TENNESSEE VALLEY AUTHORITY

In the Matter of the Application of) Docket No. 50-390
Tennessee Valley Authority)

WATTS BAR NUCLEAR PLANT

TECHNICAL SPECIFICATION CHANGES
REQUIRED FOR CERTIFICATION

Figure 15.2.1 Uncontrolled Rod Withdrawal from a Subcritical Condition
Nuclear Power Versus Time

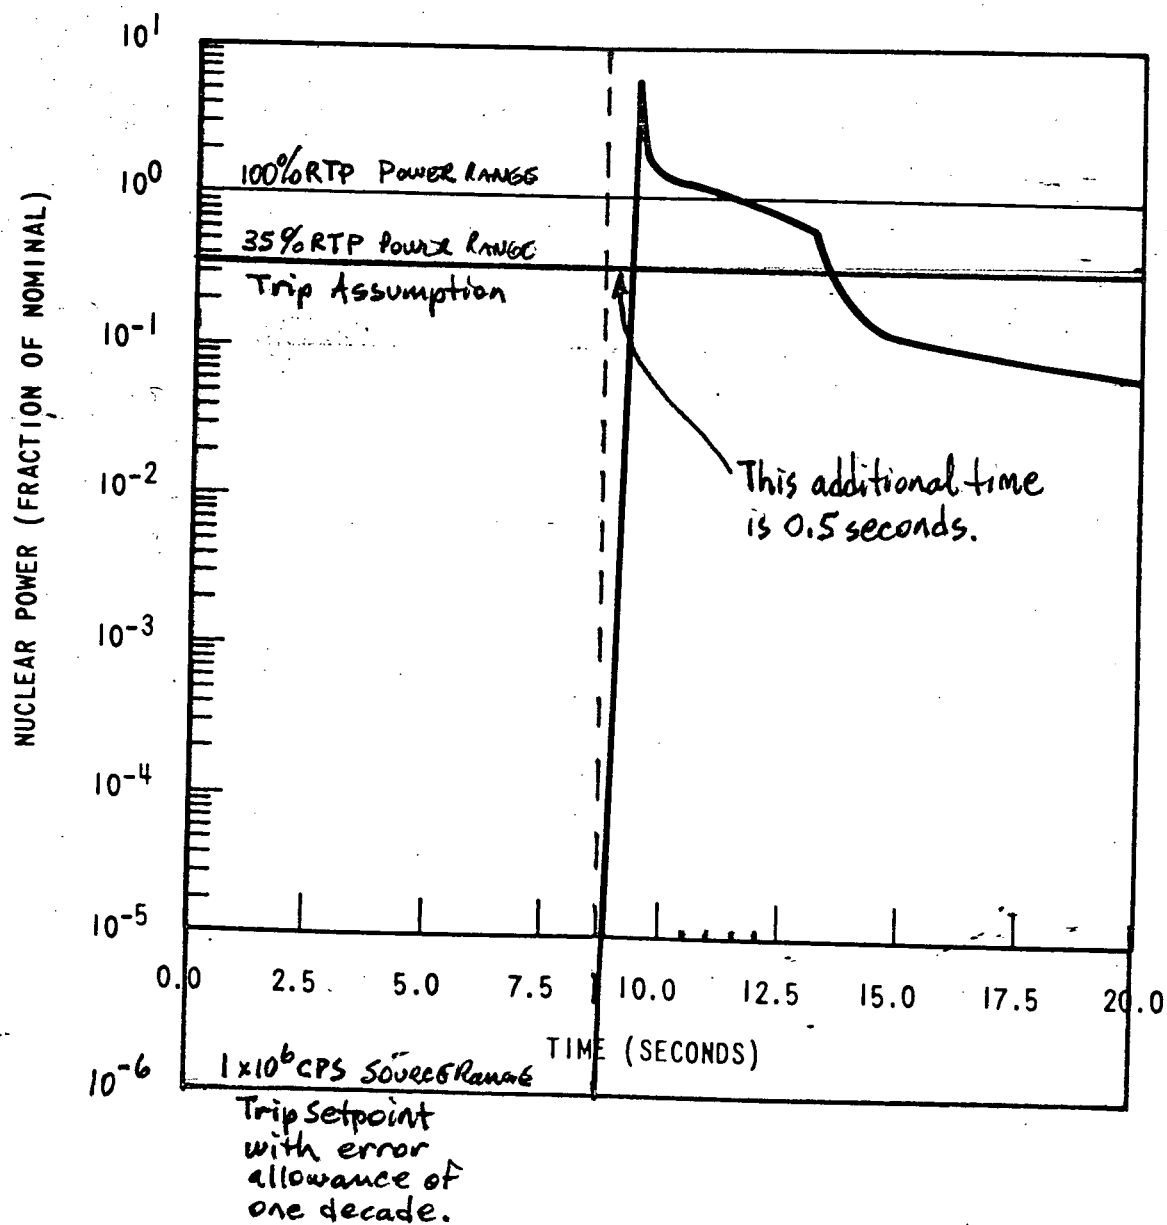
In reference 1 NRC requested additional information regarding rod withdrawal accidents in the shutdown condition (question 27). TVA responded in reference 2 that both source range detectors are required to be operable in the shutdown condition and that they provide sufficient protection with sufficient margin. TVA understands from discussions with the reviewers that it is NRC's position that Table 3.3-2 of the technical specifications should be revised to include a response time for the source range channel.

TVA has reviewed the matter and believes inclusion of a source range response time is not warranted to improve safety. This is based on the fact that the only additional portion of the system tested by this requirement would be the rack electronic equipment for the source range channel. The neutron detectors are exempt from testing, and the reactor trip breakers are timed once and added to the individual channel response times to determine overall response times. The industry experience has been that the response time of the electronic equipment has been stable and does not change.

However, if NRC believes it is important to list a source range channel response time, TVA will comply with NRC requirements. A source range response time has not been explicitly modeled in the rod withdrawal accident. Only the bounding case analysis using the power range low setpoint has been evaluated. TVA has estimated the response time for the source range channel from FSAR figure 15.2-1. The source range setpoint is approximately six decades lower than the power range low setpoint. The source range channel has this additional time to respond over the power range channel based on the technical specification definition of response time. The source range channel exceeds the setpoint six decades earlier than the power range channel, but it does not have to complete the trip action until the same time as the power range to provide the same level of protection. TVA has estimated this time to be approximately 0.5 seconds (see attached figure). Attached is a marked-up technical specification page that adds a 1.0 second response time for the source range channels.
